SERVICE CHANGES

1. Change on Cylinder, Flat Washer, Guide Ring etc.

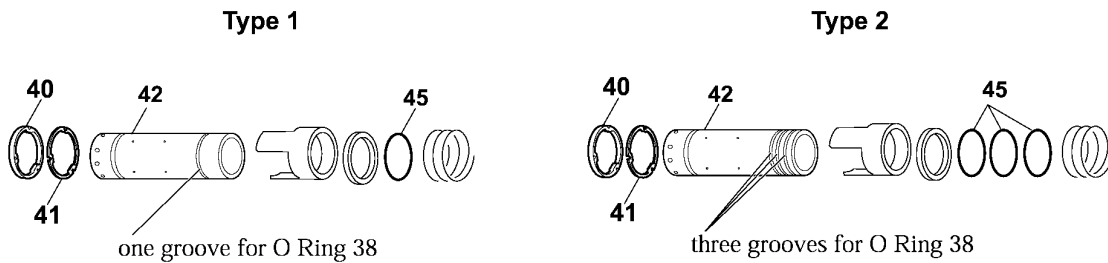
* SEE SERVICE CHANGES

Item No.	Description	Type 1	Type 2
40	Guide Ring	416927-8 Thickness: 8.0mm	417600-3 Thickness: 7.0mm
41	Flat Washer 49	344790-8 Thickness 1.0mm	344998-4 Thickness: 2.0mm
42	Cylinder Liner 44	331554-9	331608-2
45	O Ring 38	213508-7	
		1 piece	3 pieces
	Serial #	~ 2142E	2143E ~

Above parts are completely interchangeable as a set.
